# Town of Hilton Head Island Regular Design Review Board Meeting

December 11, 2018

***Town of Hilton Head Island***  
***Minutes of the Design Review Board Meeting***  
**November 13, 2018 at 12:00 p.m. Noon**  
**Benjamin M. Racusin Council Chambers**

**JAVA  
BURRITO  
CO**

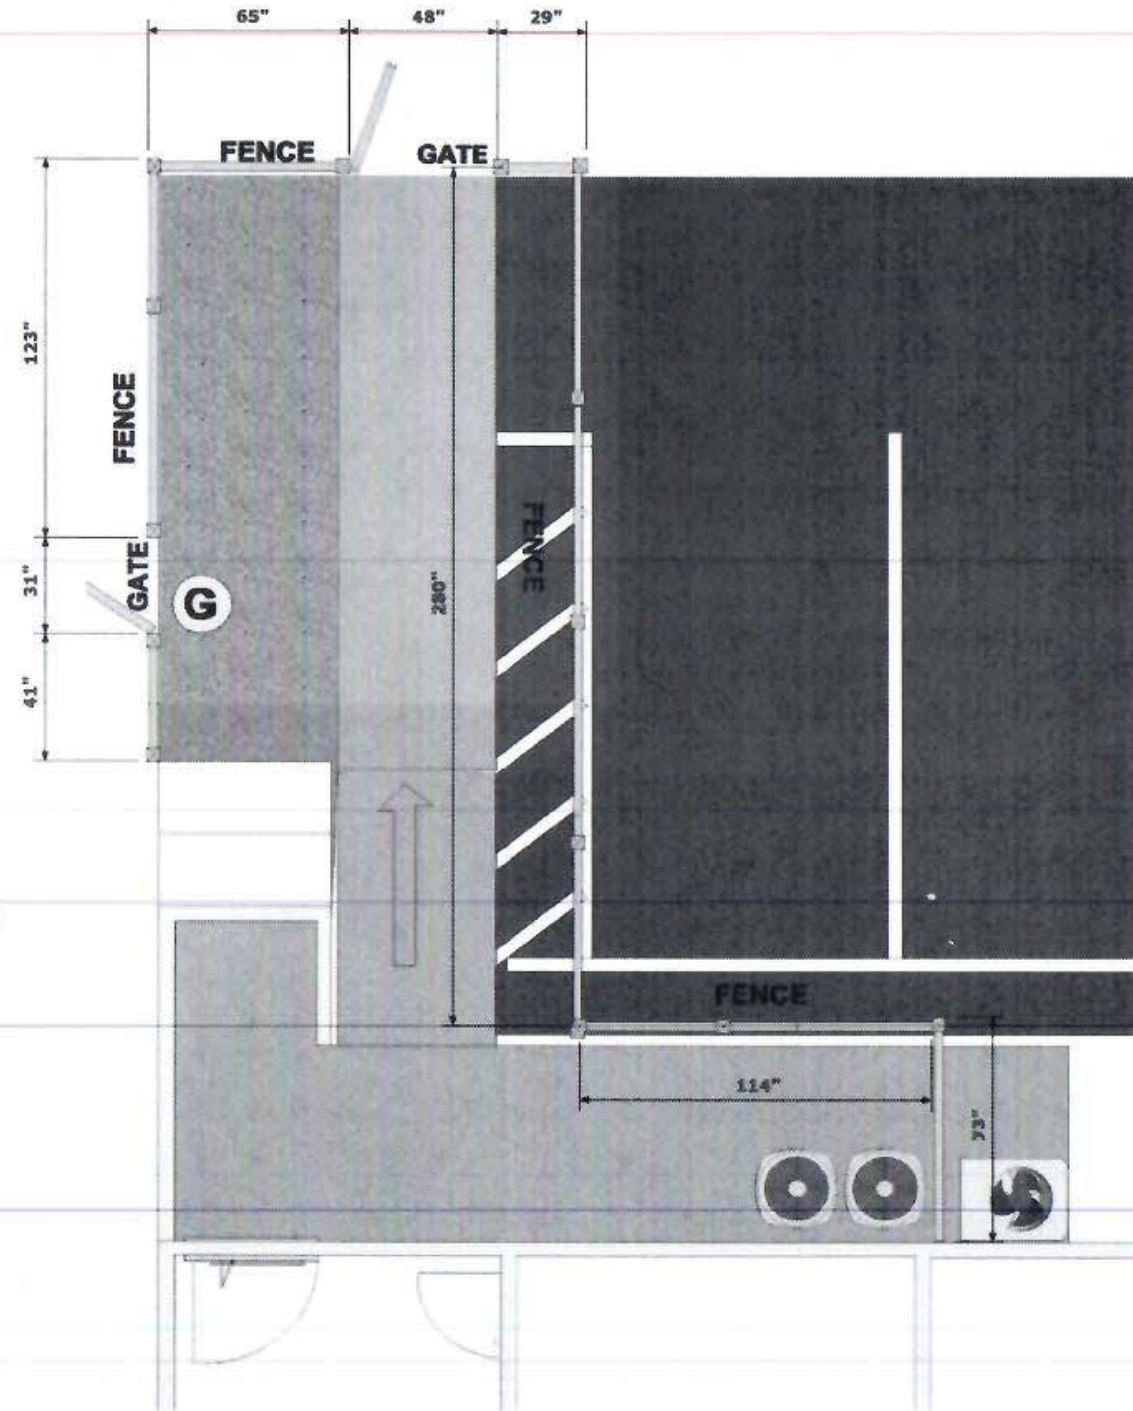
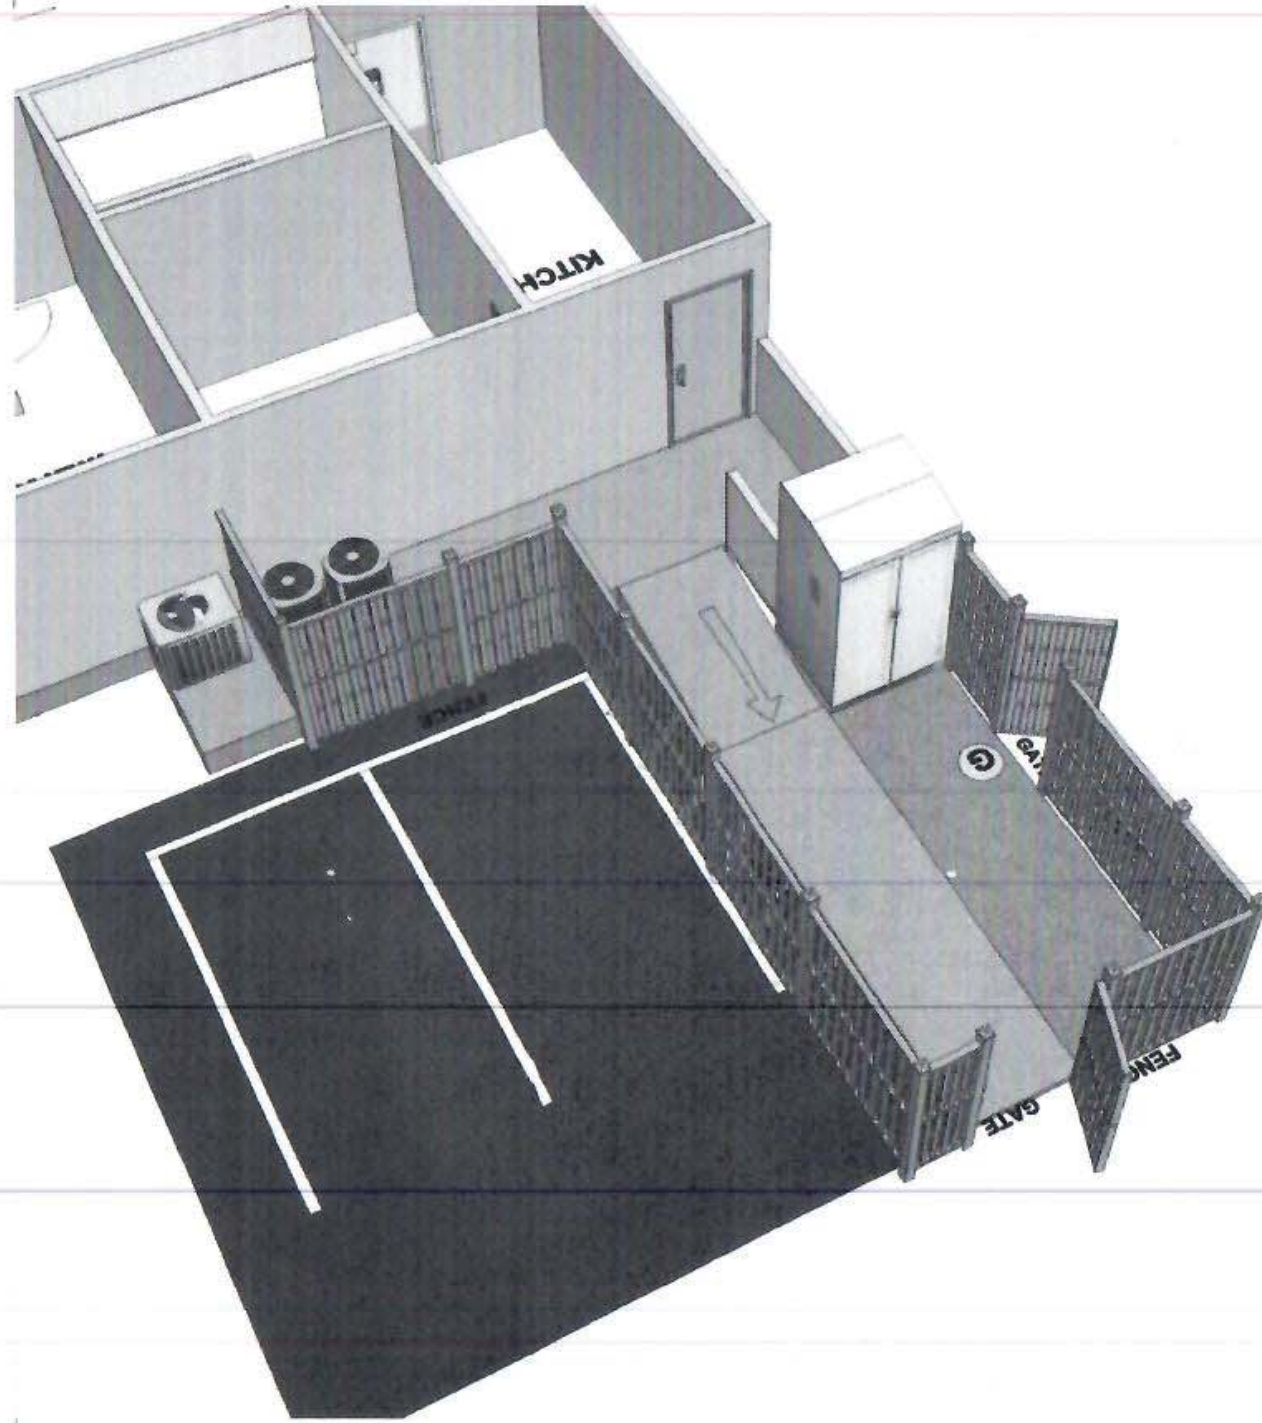
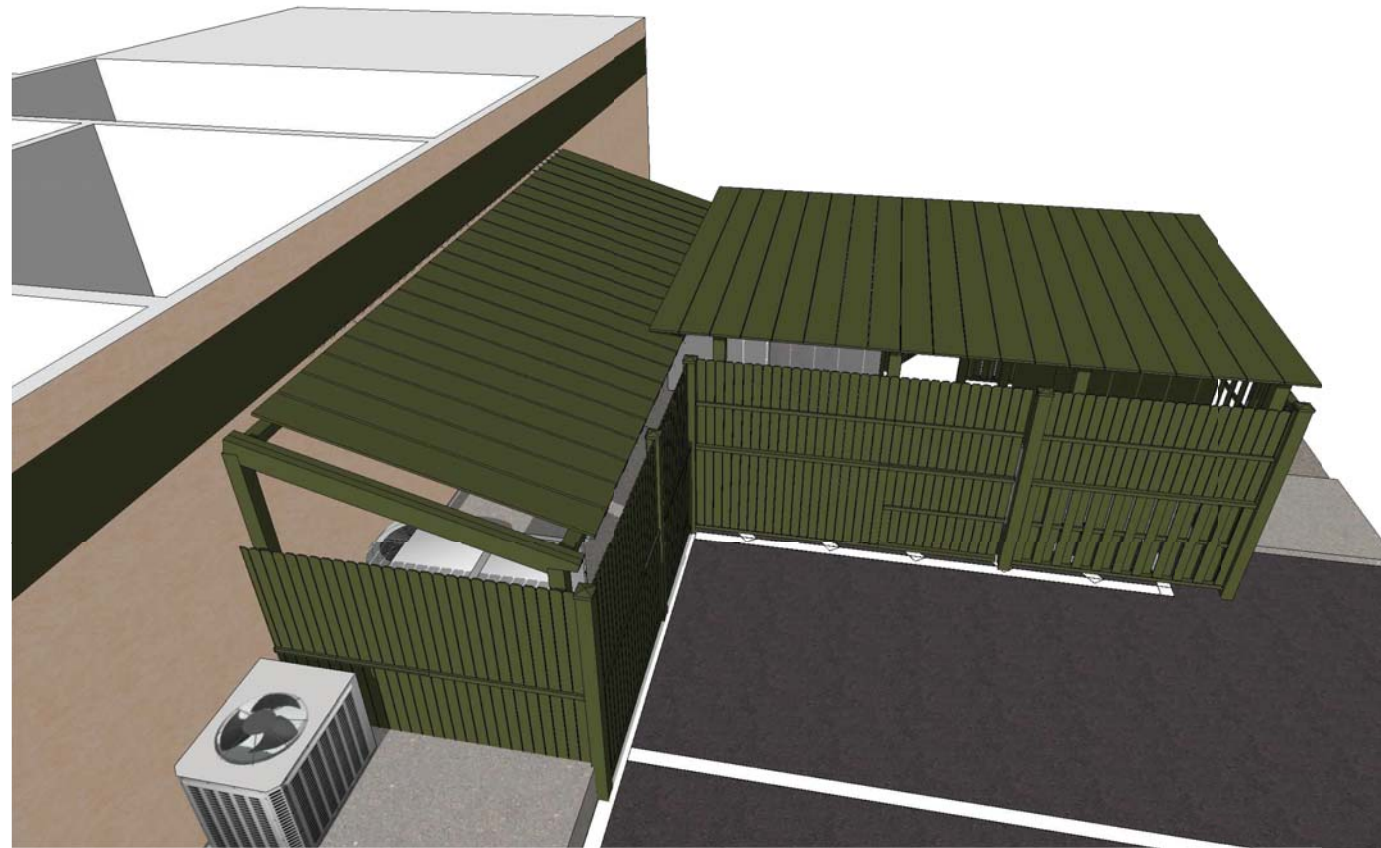
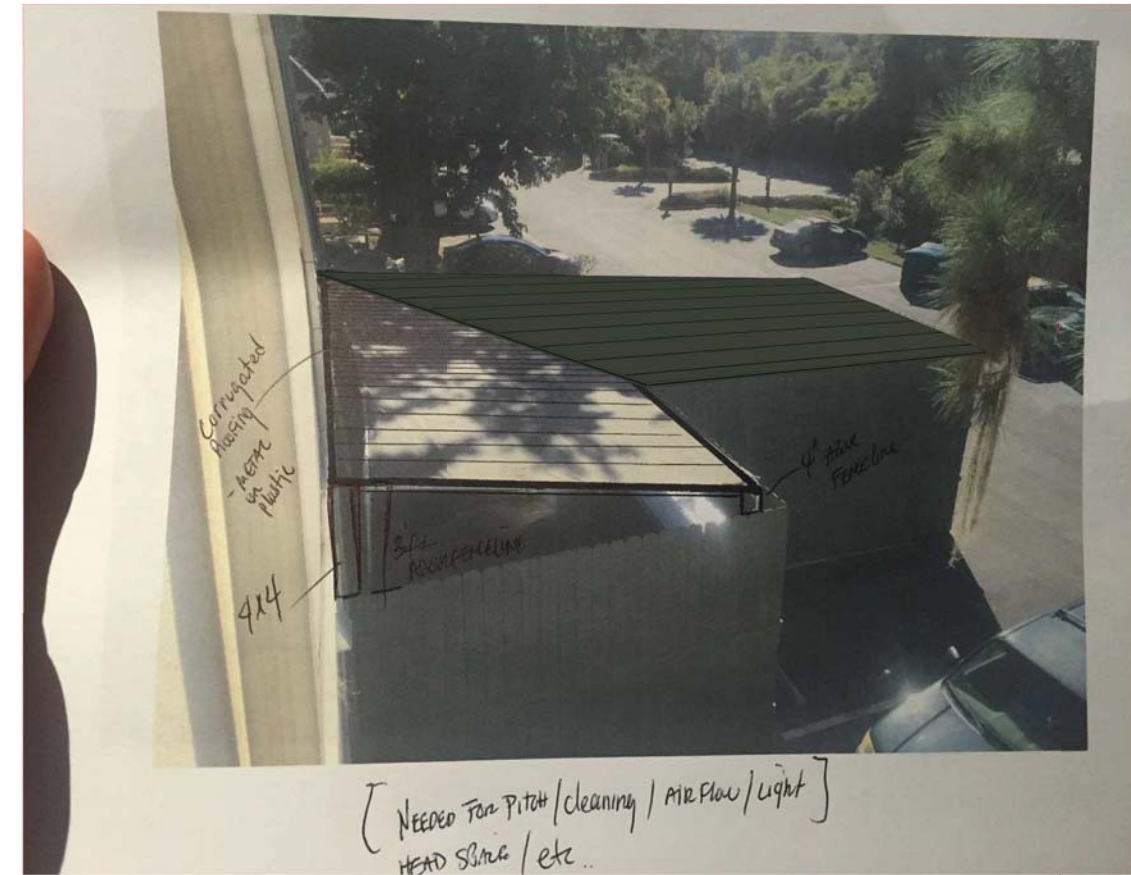
<b><i>APPLICATION MATERIAL</i></b>				
<b>DRB REQUIREMENTS</b>	<b>Complies Yes</b>	<b>No</b>	<b>Not Applicable</b>	<b>Comments or Conditions</b>
Existing Conditions match As-Built	<input type="checkbox"/>	<input type="checkbox"/>	<input checked="" type="checkbox"/>	The DRB is being asked to review and approve an existing structure.
Dimensioned Details and of Sections	<input type="checkbox"/>	<input type="checkbox"/>	<input checked="" type="checkbox"/>	The DRB is being asked to review and approve an existing structure.
Detail Illustrating Connection to Existing Structure	<input type="checkbox"/>	<input type="checkbox"/>	<input checked="" type="checkbox"/>	The DRB is being asked to review and approve an existing structure.
New Building Details Match Existing Building Details	<input type="checkbox"/>	<input type="checkbox"/>	<input checked="" type="checkbox"/>	It matches other accessory structures at Village at Wexford

<b><i>ARCHITECTURAL DESIGN</i></b>				
<b>DESIGN GUIDE/LMO CRITERIA</b>	<b>Complies Yes</b>	<b>No</b>	<b>Not Applicable</b>	<b>Comments or Conditions</b>
Has a strong roof form with enough variety to provide visual interest	<input type="checkbox"/>	<input checked="" type="checkbox"/>	<input type="checkbox"/>	The roof form does not look intentional it appears temporary and piecemeal.
Minimum roof pitch of 6/12	<input type="checkbox"/>	<input checked="" type="checkbox"/>	<input type="checkbox"/>	The roof pitch should relate (not necessarily match) the pitched mansard roof on the main building.

DESIGN GUIDE/LMO CRITERIA	Complies Yes	No	Not Applicable	Comments or Conditions
Treats the Landscape as a major element of the project	<input type="checkbox"/>	<input checked="" type="checkbox"/>	<input type="checkbox"/>	There is no room available for landscaping.
Location of existing trees and new trees provides street buffers, mitigation for parking lots, and an architectural complement that visually mitigates between parking lots and building(s)	<input type="checkbox"/>	<input checked="" type="checkbox"/>	<input type="checkbox"/>	Shrubs should be added on the right hand side where there is planting area.
